PETITIONS FOR SPECIAL EXCEPTION AND ZONING VARIANCE
4th Election District
Case No. 87-132-XA

PROPERTY ZONE: R-O
4th ELECTION DISTRICT
PROPERTY: 0.19 ACRES
REVISED PLANS
#33
DHILLON ENGINEERING, INC.
8641 Loch Raven Blvd.
Suite 3C
Towson, Maryland 21204
(301) 665-9297

BALTIMORE COUNTY ZONING PLANS ADVISORY COMMITTEE

Re: Baltimore County
Item # 33
Property Owner: Fern S. Swerdlin, et al
Location: NW/C Reisterstown Road (Route 140) and Ritters Lane
Existing Zoning: R.O.
Proposed Zoning: Spec.
Exception for a Class "B" office building
Area: 40,310 sq. feet.
District: 4th

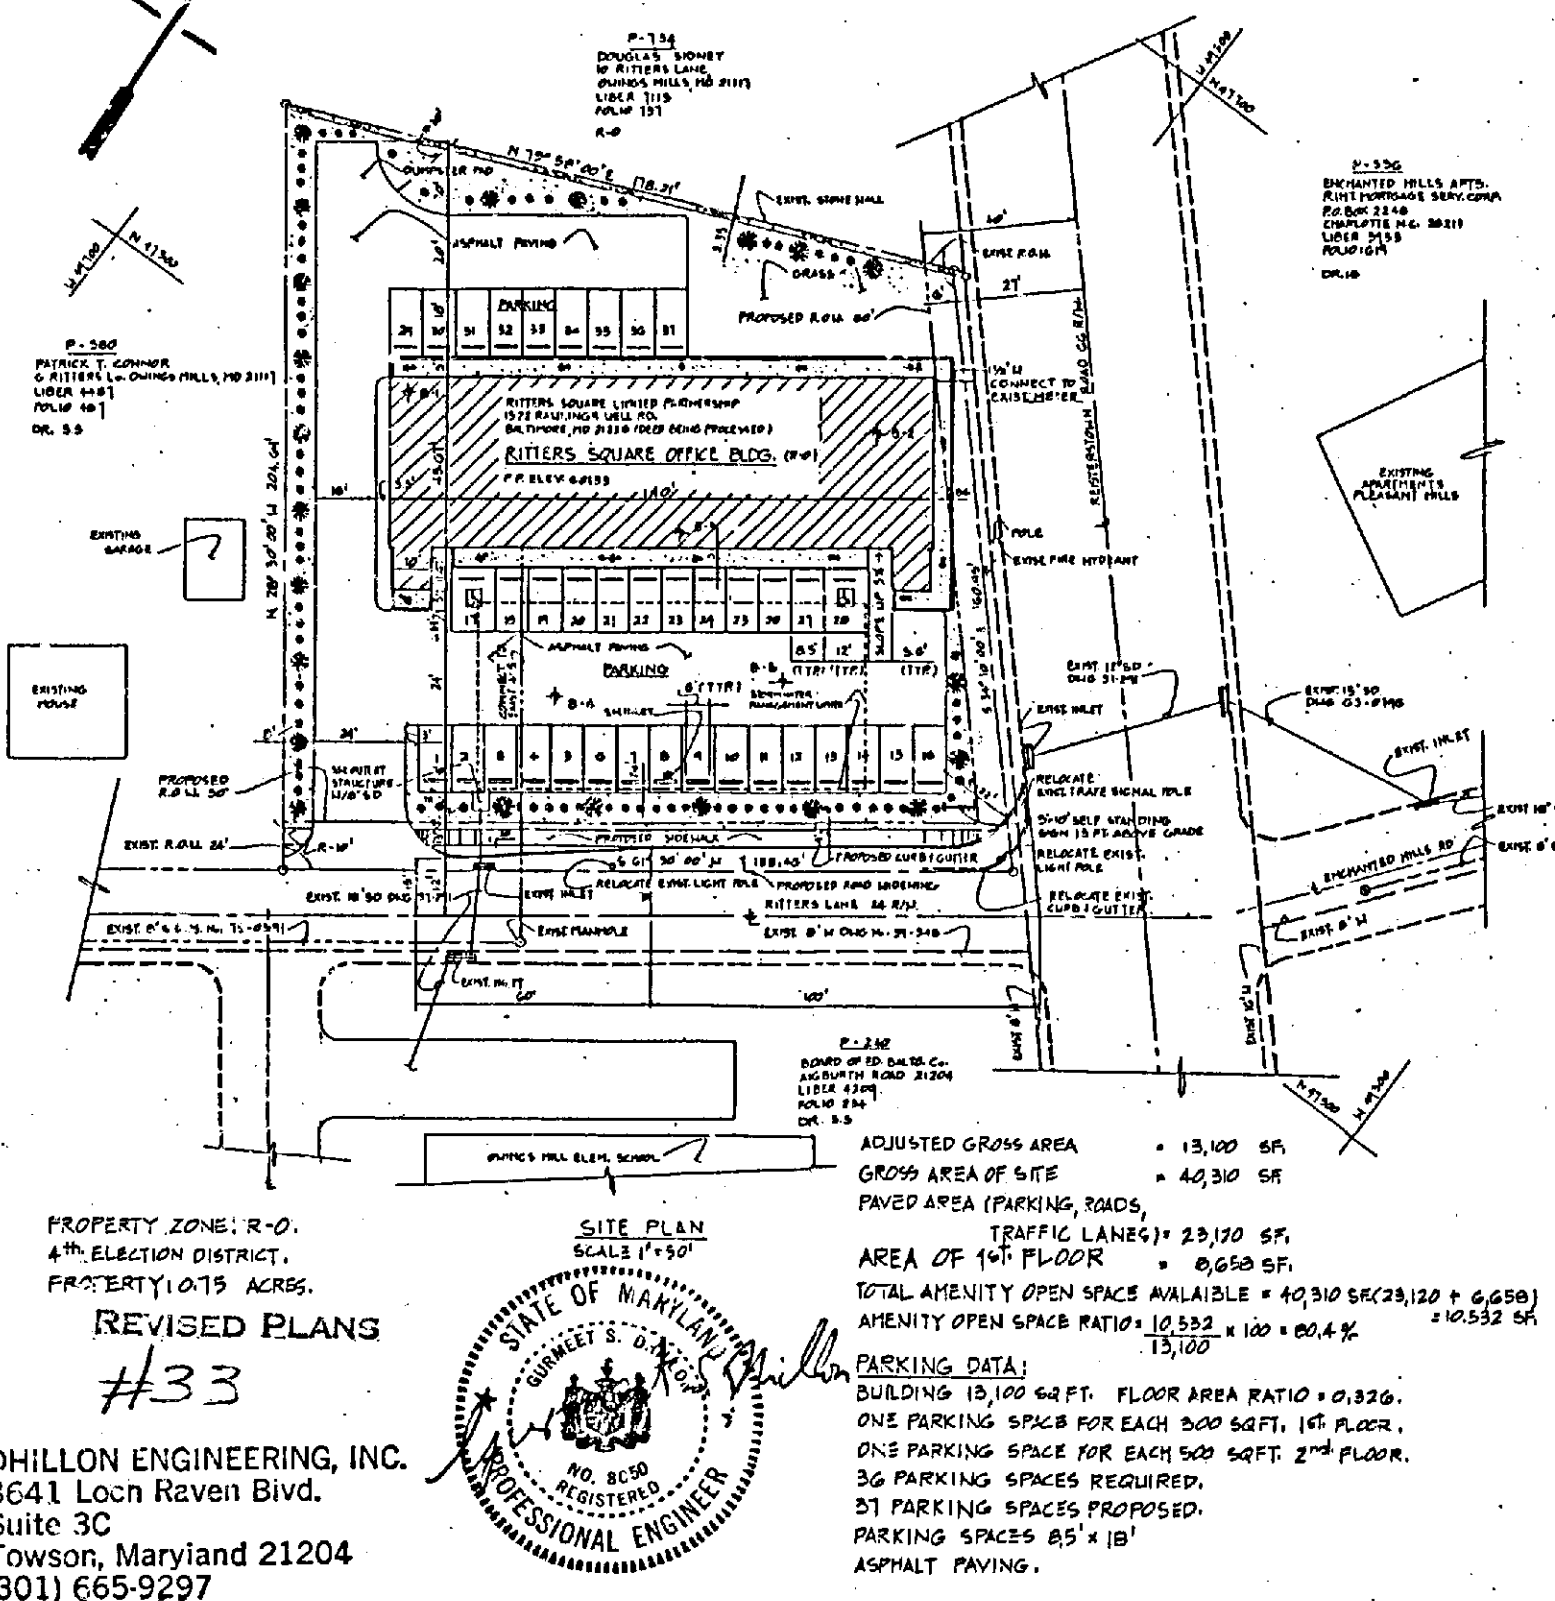
On review of the submittal and field inspection, the State Highway Administration finds the existing condition (S.H.A.-Concrete curb and gutter) along the W/S at Reisterstown Road generally acceptable, with no access requested to Route 140.

However, the site plan must be revised to show the existing 66' Right-of-Way (33' x section) and the proposed 80' Right-of-Way (40' x section) for Reisterstown Road.

Any improvements to the N/S at Ritters Lane required by Baltimore County in the form of concrete curb and gutter will require modification of the N/W radius at Route 140 and Ritters Lane to 30'.

It is requested the site plan be revised prior to a hearing date being set.

(See attached sketch)

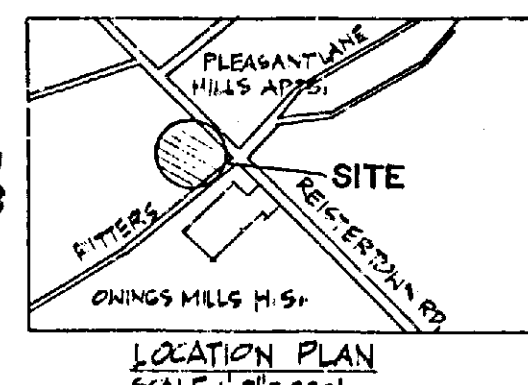
1. The entrances to the site must not be less than 24' wide, with at least a 20' radius on the east side of the driveway.
2. The right-of-way on Ritters Lane should be widened to a point 25' from the center line of the road. Ritters Lane should be widened 18' from the center line of the road, with a 30' radius at Reisterstown Road.
3. A sidewalk should be provided along the entire frontage of the site and along the west side of the building between the two parking lots.
